SCREENING PLAN
APPROVED ON CONDITION*
BOARD OF ZONING ADJUSTMENT
BY D. Denny 5/6/80

FINAL SCREENING PLAN
H. E. Rudy Consulting Engineers
300 W. MAIN LOUISVILLE, KENTUCKY 40202

R-7 COND. USE FOR DENTIST'S OFFICE
PRELIMINARY SITE DEVELOPMENT PLAN
FOR
DON FORD
LOT 5, BLOCK "G", REV. PLAN OF NORWOOD PLACE

SITE PLAN
Scale: 1"=100'

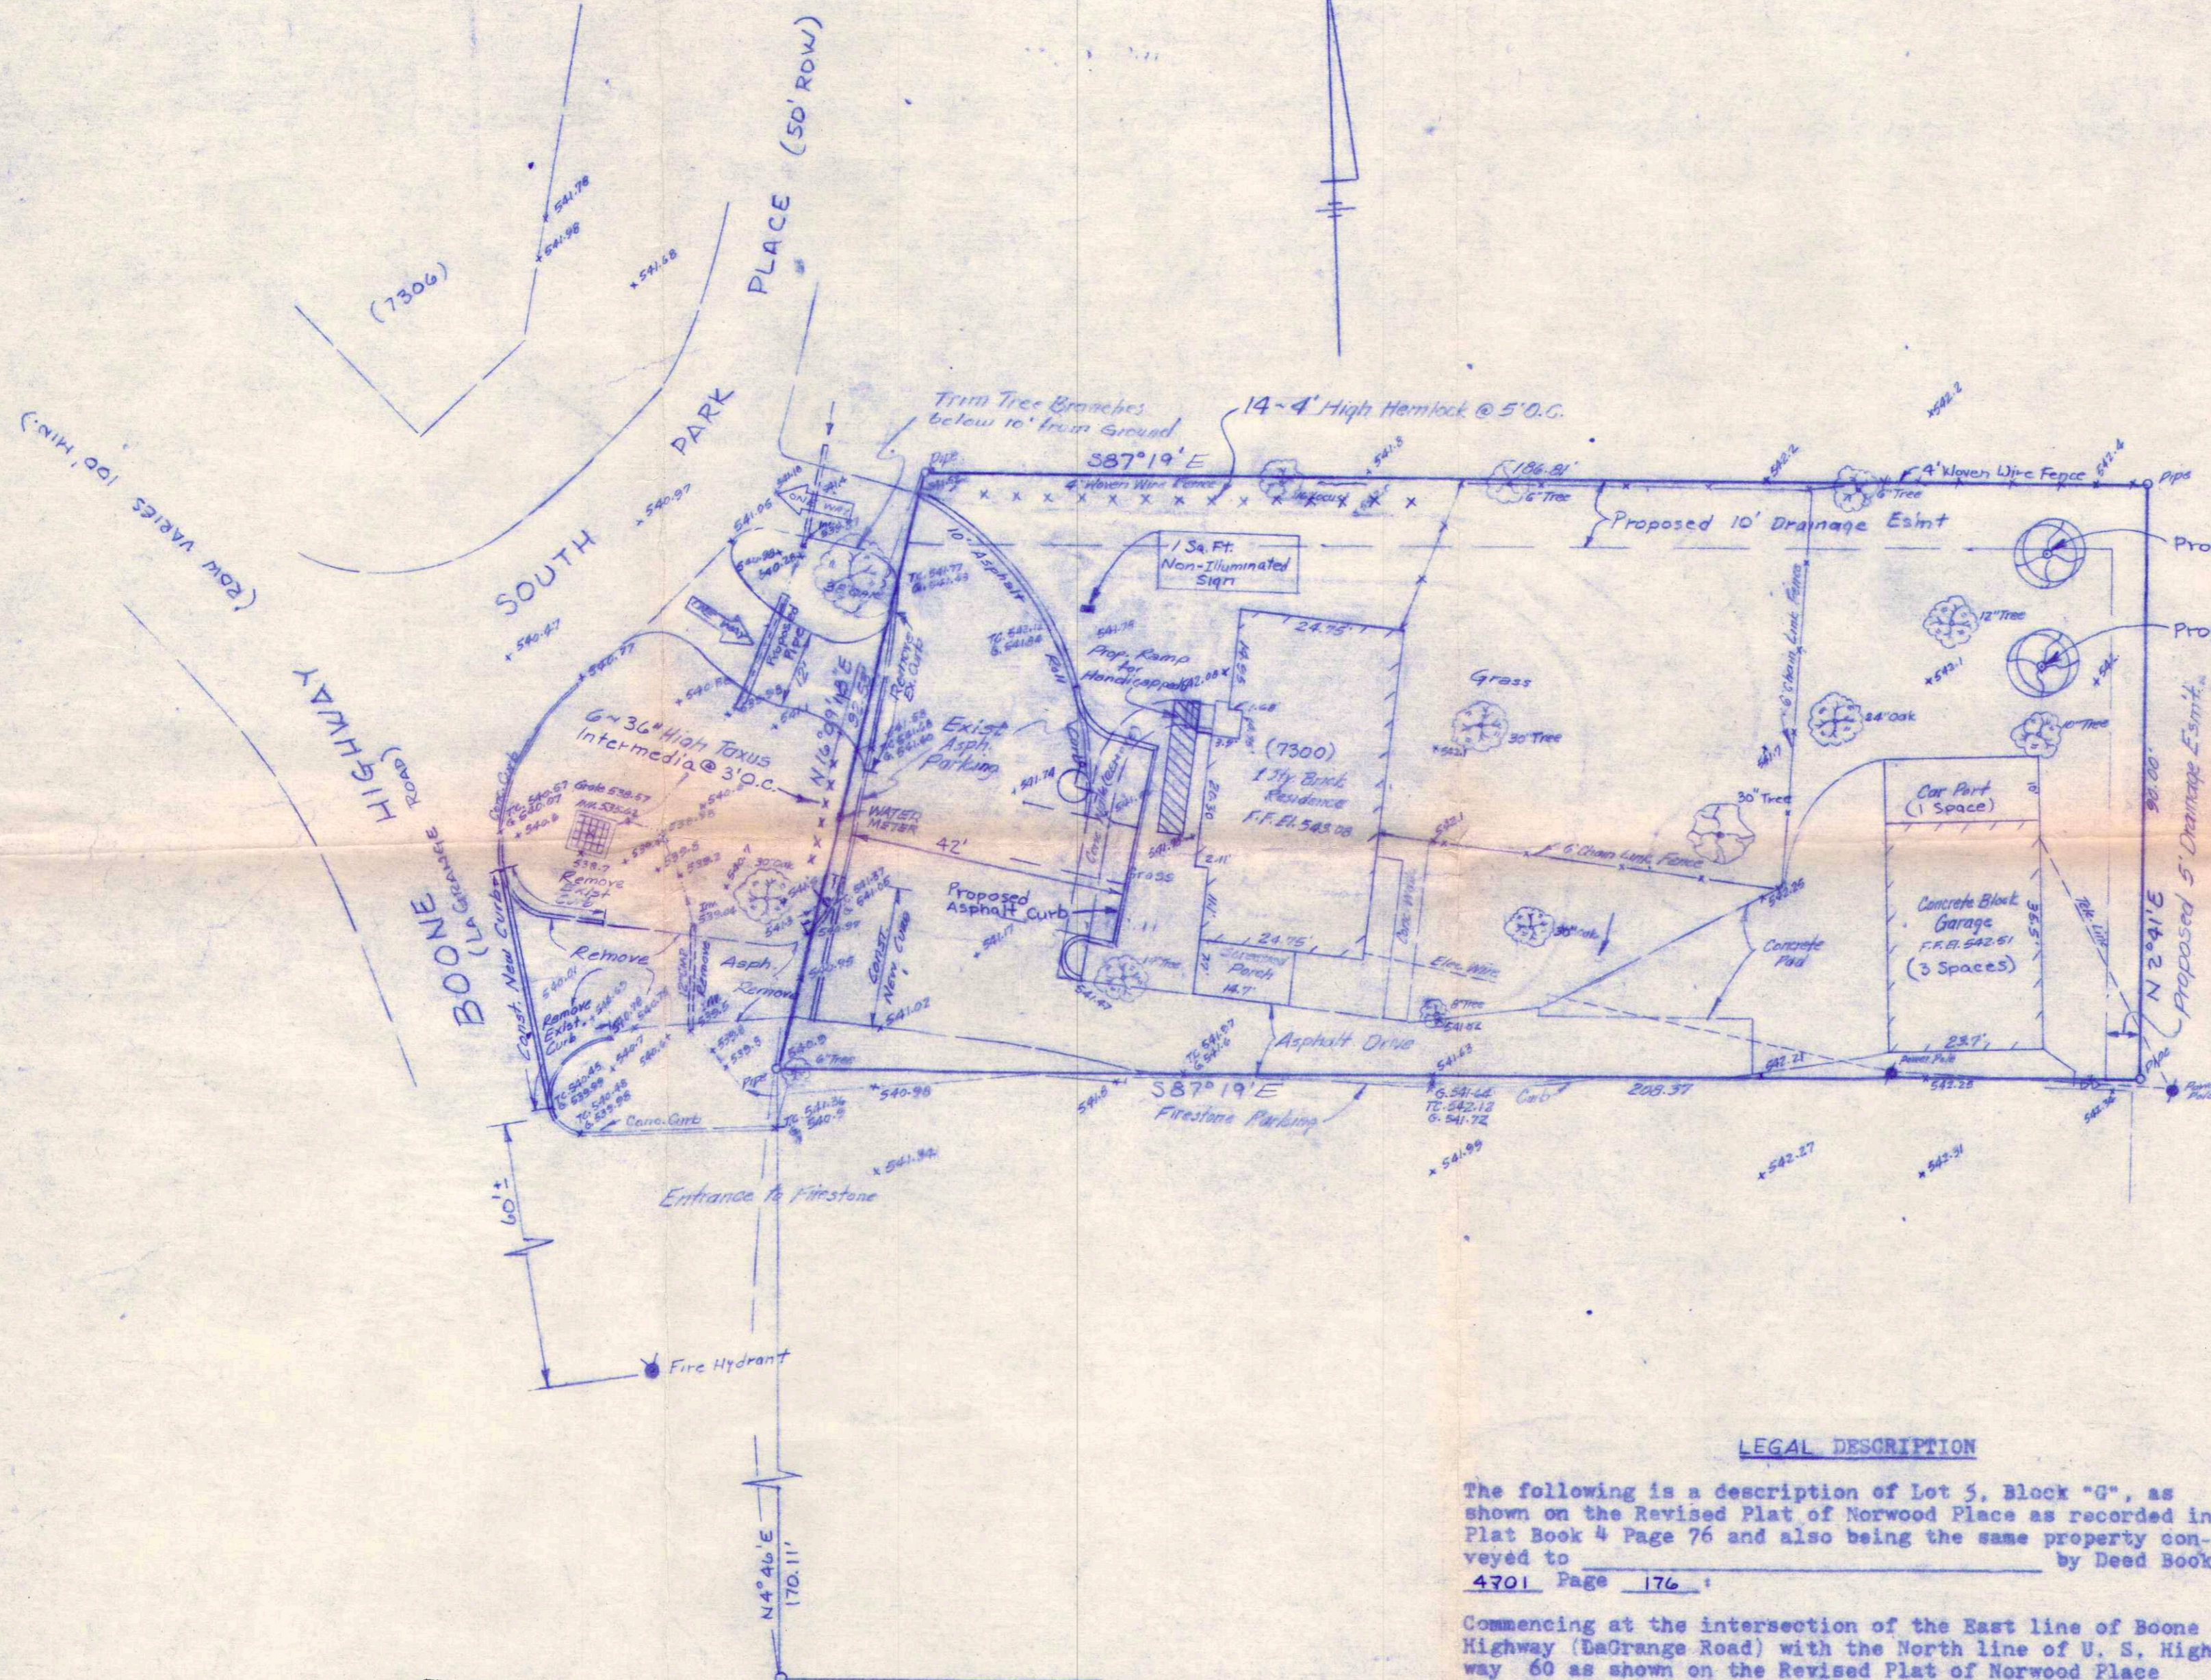
- * 1) AEM LOCKS SHALL BE PLANTED AT 4' AND BE MAINTAINED AT A HEIGHT OF AT LEAST 5'
- 2) TAXUS INTERMEDIA SHALL BE PLANTED AT A HEIGHT OF 3' AND BE MAINTAINED AT A HEIGHT OF AT LEAST 3 1/2'
- 3) THE TWO LARGE TREES IN THE FRONT SHALL BE PRESERVED
- 4) IF FENCE ALONG NORTH SIDE PROPERTY LINE IS REMOVED EVERGREENS SHALL BE SUBSTITUTED IN ITS PLACE
- 5) THE SCREENING SHALL BE IMPLEMENTED AS SHOWN ON THIS PLAN.
